Evaluation of NuScale Post ECCS Actuation Boron Dilution Events

Revision 1.

**Division of Safety Systems
Office of Nuclear Reactor Regulation**

July 6, 2020

Figure 1. NPM module under post ECCS actuation condition and non-safety injection points.

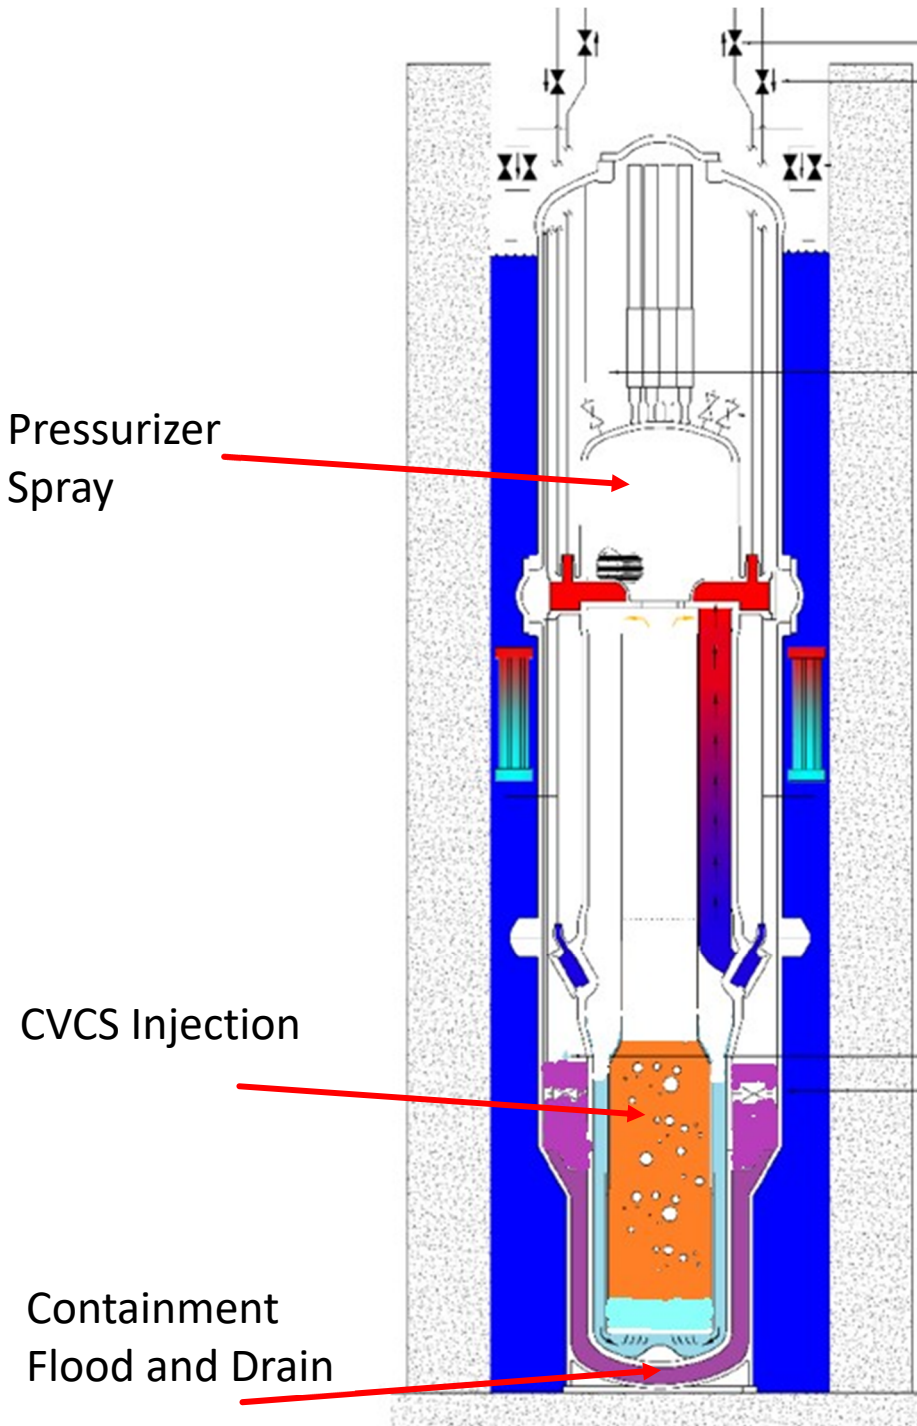
1. If the operator has the CVCS available and starts to inject the cold water into the riser, the cold water will shrink the riser void fraction and cause a surge of diluted water from lower plenum and downcomer into the core. The resulting consequence could be the return to power. In addition, if the CVCS was in the dilution mode of operation prior to the event, the discharge line initially contains fresh water. The cold and fresh water injection on top of the core could make the return to power worse.

2. If the operator has the Pressurizer Spray available and start to inject the cold water into the pressurizer spray, the cold water will depressurize the RCS and cause the riser fluid flashing and void fraction increase. The resulting consequence could be the surge of diluted water into the core and return to power.

3. If the operator initiates the Containment Flood and Drain System, the injection at 100 gpm rate could also push a slug of diluted water into the core.

Figure 2. Gaps of NuScale Design and Analyses Related to Boron Dilution Phenomenon

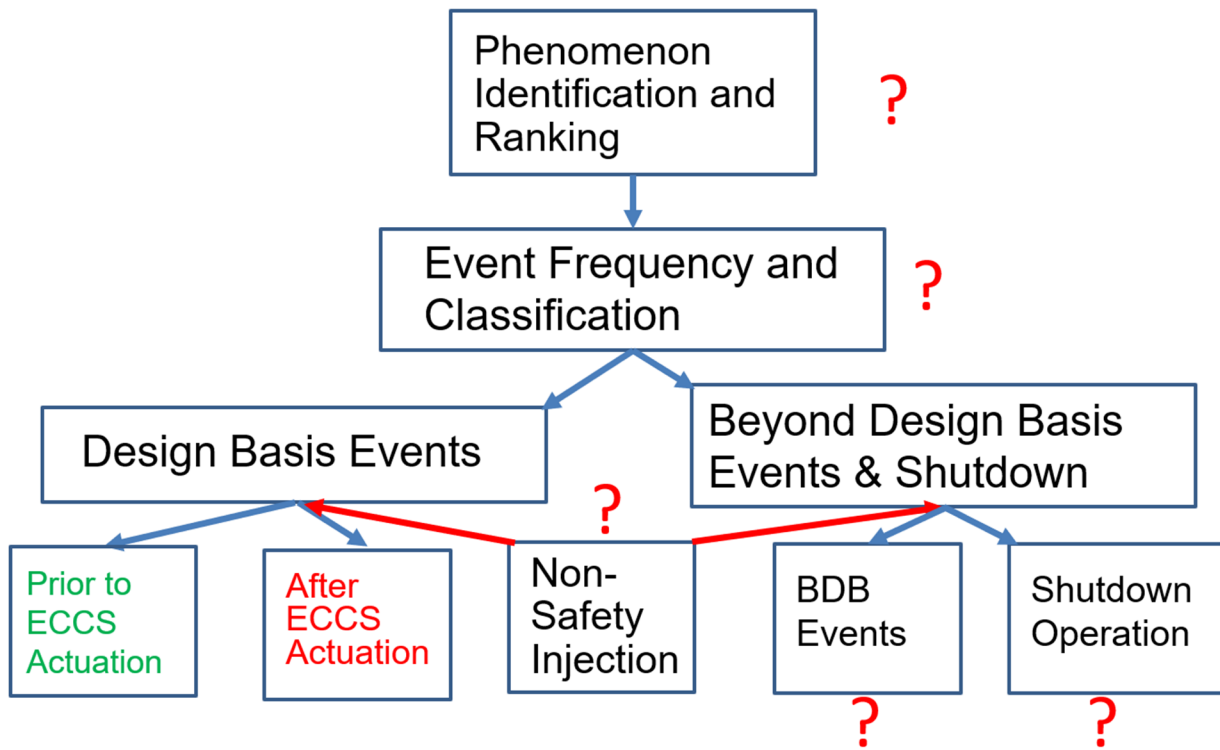
]]. Along this line, the author found that NuScale's overall approach missed the interrelated parts of the design and analyses associated with the boron dilution phenomenon. The weakness started from the PIRT process. It then cascaded through the event characterization, the event tree development, the PRA analyses, the LOCA spectrum analysis, the post ECCS actuation boron transport analyses and the core neutronics design evaluation. As the result, for the post ECCS actuation operation, the current design basis analyses missed the most limiting return to power transients which would cause significant core damage with an unacceptable frequency and risk.

The transport phenomenon associated with diluted water slug movement may not have been identified completely. For example, the riser surge and core flow increase could be caused by the injection through spray or the lower riser injection nozzle during the post ECCS actuation operation. Other transport phenomenon and mechanisms are the manometer type of flow oscillation under low pressure and low temperature post ECCS operating conditions. NuScale, however, has not identified these transport mechanisms as the potential core dilution contributors nor evaluated the consequence of this type of flow instability. Figure 2 shows the deficiencies of the analyses and the design effort from a bird's eye view. Because of these gaps, it is considered unacceptable.

Figure 3. NPM Post ECCS actuation Fluid Volume and Boron Concentration Distribution.

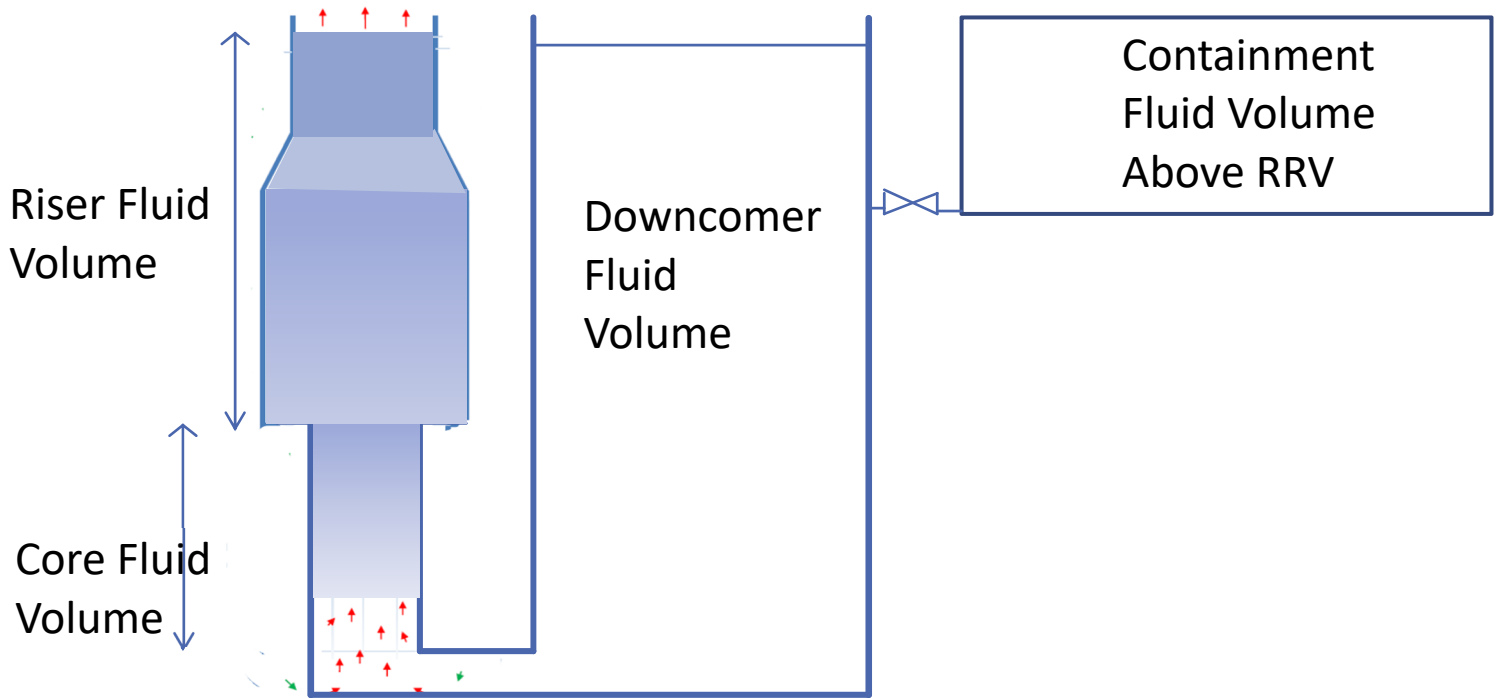
As it is shown in Figure 3, NuScale module has a very unique fluid volume distribution. From the perspective of maintaining core collapsed water level during ECCS operation, there is an ample margin. For boron transport, after the ECCS actuation, the downcomer and lower plenum becomes diluted quickly. The system becomes an "unstable" boron distribution pattern with a relatively small core fluid volume and [[]] more fresh or diluted water in the lower plenum, downcomer and the containment ready to move into the core. Any system disturbances, such as non-safety system injections, manometer type of oscillation or flow instability may have a good chance to turn the unstable steady state into a transient with a large amount of fresh water getting into the core.

Figure 4. VERRA Test Facility and Its Relevance to NuScale Boiling Length Calculation

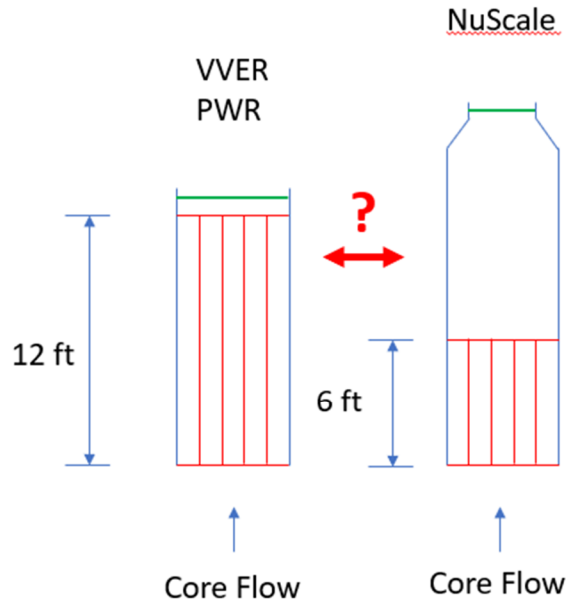
In response to author's concern, NuScale identified one VVER boron precipitation test in October 2019. According to NuScale, the test shown lower boron concentration below the elevation of the boiling length of the VERA test facility. Since then, NuScale has been assuming that anything below the boiling length has [[]] for its criticality margin assessment. Although this approach is better than the [[]] assumption, the author examined the relevant VERRA test report and found the results may not be conservative either.

The Finish VEERA test facility was designed to measure boric acid concentration distribution during the VVER (PWR) boron precipitation scenario. Figure 4 shows the test facility and a simple relevance drawing of the facility. VERRA test facility has a 12 ft bundle with only about 0.1 meter of water on top of the bundle. NuScale has 10 ft water above the core with a core height of 6 ft. Because of this mismatch, the author expects that NuScale has longer diluted non-boiling region than what was measured in VERA. Therefore, the use of VERA test data to determine the NuScale non-boiling length is non-conservative

Figure 5. German Boron Volatility Test Facility For BWR ATWS Application

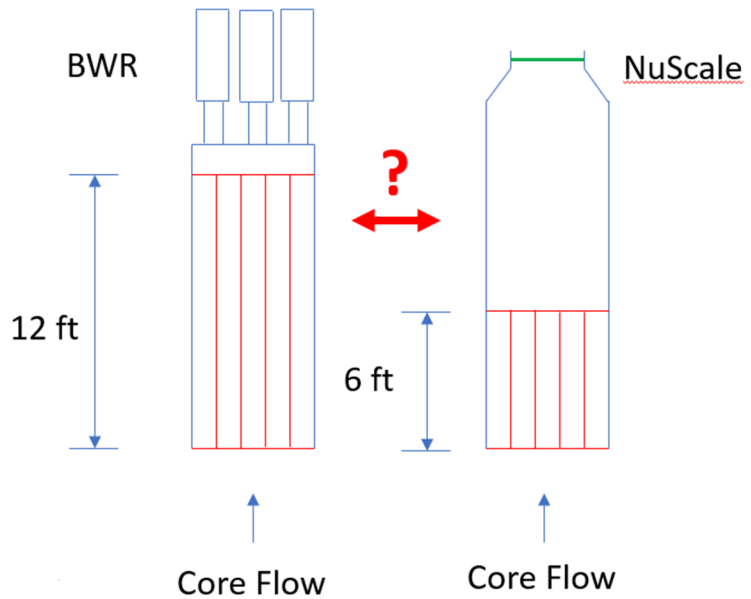
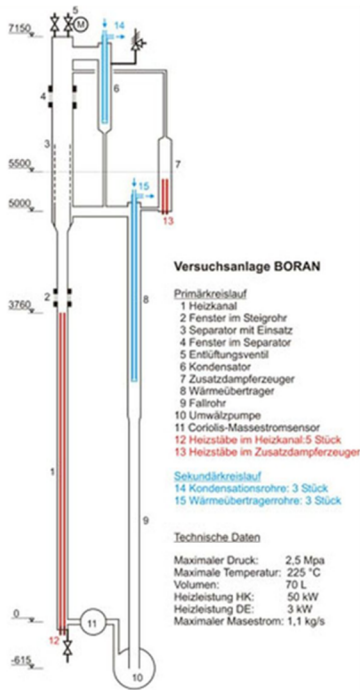
Volatility plays a gradually significant role with a time span beyond 10 hours. As shown in Figure 5, NuScale adopted a German correlation developed for BWR ATWS SLC injection scenario. The heated section has a height of 12 ft and the mass flow rate is close to 100 times more than NuScale boil off rate. Not only the test was not scalable to NuScale condition, but also the correlation predicted much lower value than both WAPD data and 1999 Chemical Thermodynamic Journal data by a factor of 2.0 (Figure 6). The staff also performed sensitivity analyses and predicted the return to power within 72 hours once other volatility correlations are used.

Figure 6. Comparison of German Volatility Correlation With Other Test Data.

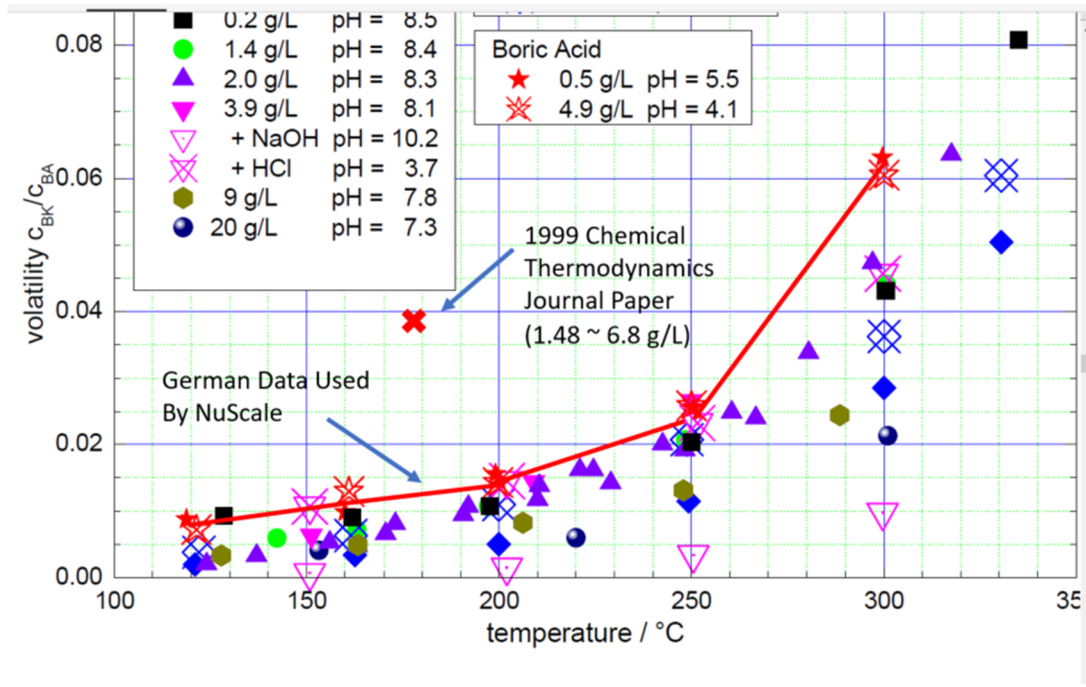
Although NuScale’s analysis has some other conservatisms, both the volatility correlation and the non-boiling length calculation are considered non-conservative. The overall conservatism can hardly be proved with two major uncertainties from NuScale’s approach. Therefore, the author does not believe that we have reasonable assurance to approve NuScale’s boron dilution analysis and their claim that there is no return to power as long as there is boron in the RCS.
